**Comments from India on the GTR for Passenger Vehicle Tyres
under formulation by the Working Group on Tyres**

Fig. 1

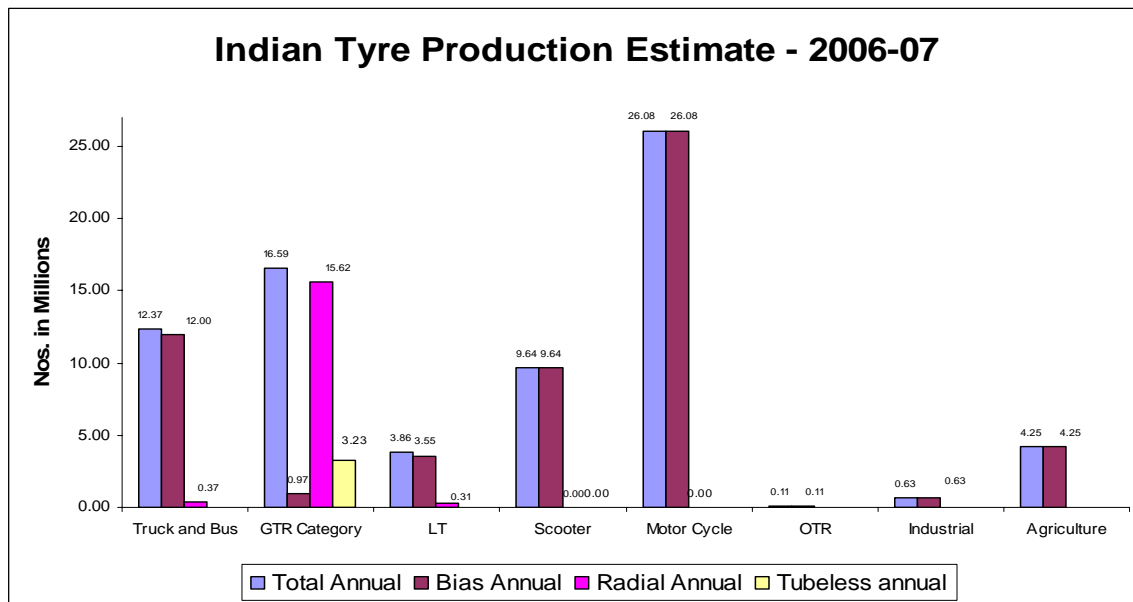
India has large number of Bias tyres still manufactured. The total tyre production (including commercial, passenger, scooter/motor cycle and agricultural vehicles) is estimated to be about 74 million. Out of which, 57 million are Bias ply tyres for the Indian tyre production estimated for the year 2006-07. In passenger segment (which includes LT category also for less than 1250 kg load capacity), the Bias production is about 1.0 million and Radial 15.6 million. The production of Bias tyres is likely to continue for many years (and may even slightly grow in certain applications like non -highway tyres). Bias tyres also constitute a significant part of tyre exports originating from India.

Among the 15.6 million radial tyres produced in the passenger category, only about 3.2 million are in the tubeless category and remaining 12.4 million in tube type. The tubeless production is growing, but complete changeover would take time.

As Bias tyre production and Tube type tyre production is expected to continue in India for more than a decade, these categories need to be addressed in the GTR. This will also help in including some other specific items pertaining to Bias tyres.

Fig. 3

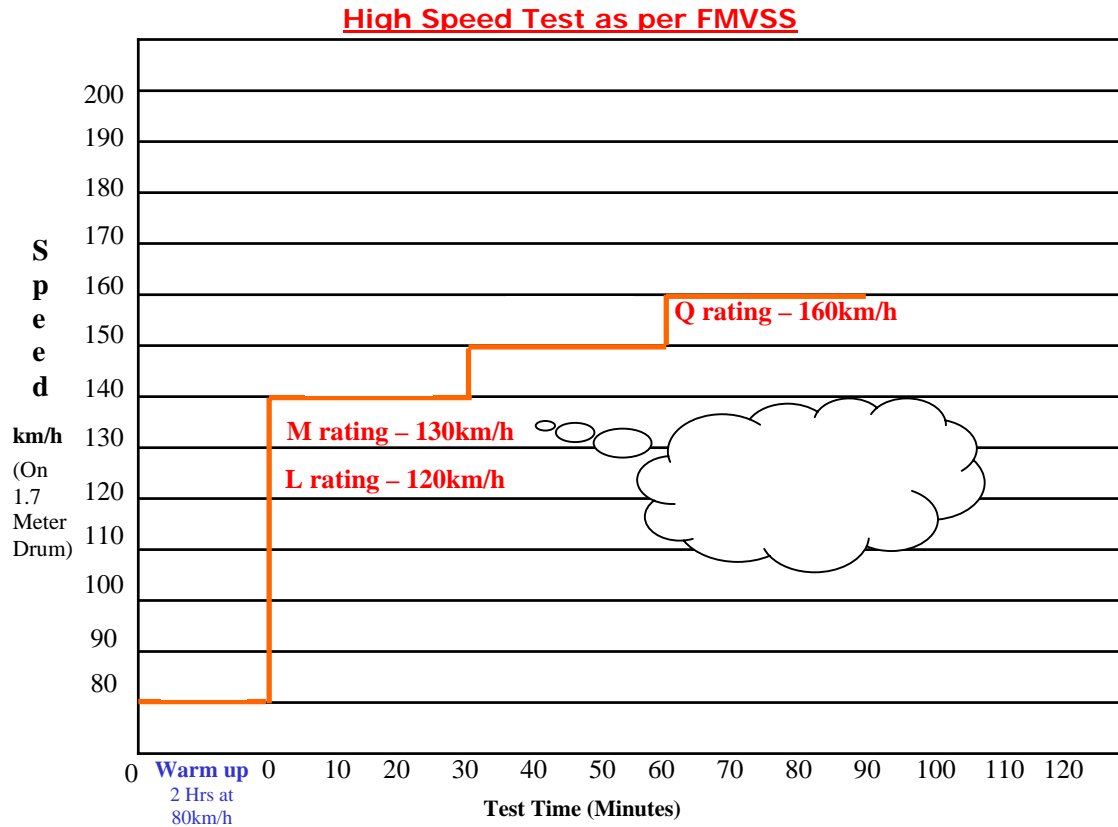
Based on the existing running sizes used in India, there is a group of sizes which have speed ratings from "L" to "Q" (which is 120km/h to 160km/h). This group has max. load capacity of less than 1250 kg, hence does qualify under category of tyres being covered under GTR.

- a) 7.00 R 16 12 PR LT, load capacity 1215 kg, speed rating M
- b) 7.00 R 15 10 PR LT, load capacity 1050 kg , speed rating M or Q
- c) 185/85 R16 8 PR LT, load capacity 925 kg, speed rating Q
- d) 185 R 14 8 PR LT, load capacity 850 kg, speed rating Q

This group, by virtue of its speed rating range, cannot be tested as per FMVSS 139.

The tests applicable to such types of LT tyres needs to be clearly defined and addressed . For example such tyres may not need a high speed test but can have step load test like ECE54.
